# UNITED STATES PATENT AND TRADEMARK OFFICE

APPLICATION NO.	FILING DATE	FIRST NAMED INVENTOR	ATTORNEY DOCKET NO.	CONFIRMATION NO.
10/726,601	12/04/2003	Chih-Min Chang	CHAN3234/EM	6965
23364	7590	04/28/2005	EXAMINER	
BACON & THOMAS, PLLC 625 SLATERS LANE FOURTH FLOOR ALEXANDRIA, VA 22314			SHAKERI, HADI	
			ART UNIT	PAPER NUMBER
			3723

**Office Action Summary**

## DETAILED ACTION

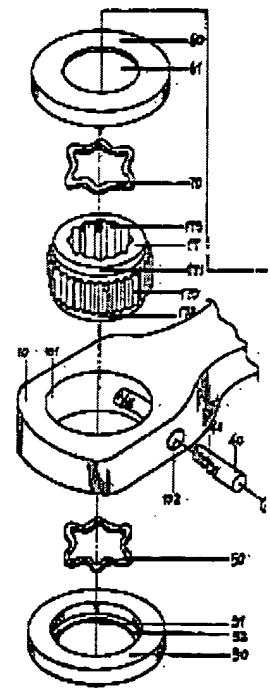
- Claims 1-3, 5, 6, and 17 are rejected under 35 U.S.C. 102(b) as being anticipated by Lee (4,991,468).

Lee discloses all of the limitations of claim 1, i.e., a ratchet wrench including a handle having a hole at an end thereof; a ratchet wheel (17) having a polygonal hole at a center thereof, a first teeth portion at an annular outer surface thereof, and two engagement portions (171) (172) disposed respectively at opposite ends thereof; said ratchet wheel being rotatably mounted in the hole of the handle with the engagement portions protruded out of the hole of the handle; a pawl (40) mounted in the hole of the handle and having a second teeth portion detachably meshed with the first teeth portion of the ratchet wheel, and two annular members (30) (60) firmly fastened to the engagement portions of the ratchet wheel respectively, said annular member each having an outer diameter greater than a diameter of the hole of the handle.

Regarding claims 2 and 3, Lee meets the limitations, e.g., engagement portions coaxially disposed.

Regarding claims 5 and 6, Lee meets the limitations, e.g., embossments (70) provided at a wall of the hole of the annular members and engagement portion of the ratchet wheel.

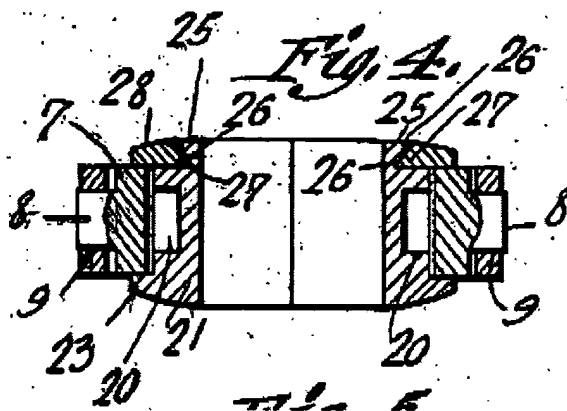
3. Claims 9-11 and 13-16 are rejected under 35 U.S.C. 102(b) as being anticipated by Cross (1,331,956).

Cross discloses all of the limitations of claim 9, i.e., a ratchet wrench including a handle having a hole (an opening through something as defined by Webster) at an end thereof; a ratchet wheel (21) having a polygonal hole at a center thereof, a first teeth portion at an annular outer surface thereof, an engagement portion (24,25) at one end, an annular flange (23) having a diameter greater than the hole at the other end; said ratchet wheel being rotatably mounted in the hole of the handle with the engagement portion and the annular flange protruded out of the hole of the handle; a pawl (19) mounted in the hole of the handle and having a second teeth portion detachably meshed with the first teeth portion of the ratchet wheel, and an annular member (28) firmly fastened to the engagement portion of the ratchet wheel respectively, said annular member having an outer diameter greater than a diameter of the hole of the handle.

Regarding claims 10 and 11, Cross meets the limitations, e.g., engagement portions coaxially disposed.

Regarding claims 13 and 14, Cross meets the limitations as recited, i.e., "embossments" (8) and (9).

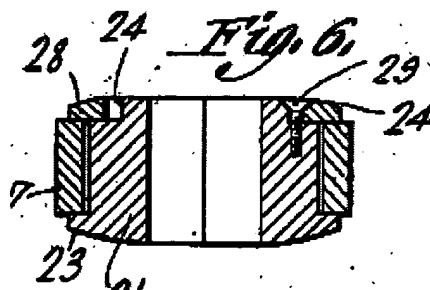
Regarding claims 15 and 16, Cross meets the limitations as recited, i.e., screw thread connection (29) and sloped surfaces (26) and (27).

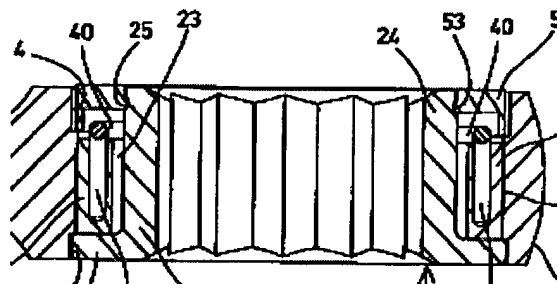
6. Claims 7 and 8 are rejected under 35 U.S.C. 103(a) as being unpatentable over Lee in view of Cross.

Lee meets all of the limitations of claims 7 and 8, except for screw thread connection between the engagement portions and the annular members; using sloped section to secure these parts. Cross teaches securing an annular portion with an engagement portion using sloped sections (26) and threaded connection (29). It would have been obvious to one of ordinary skill in the art, at the time the invention was made, to modify the invention of Lee with the different means of connecting the engagement and annular portions as taught by Cross to securely hold these parts.
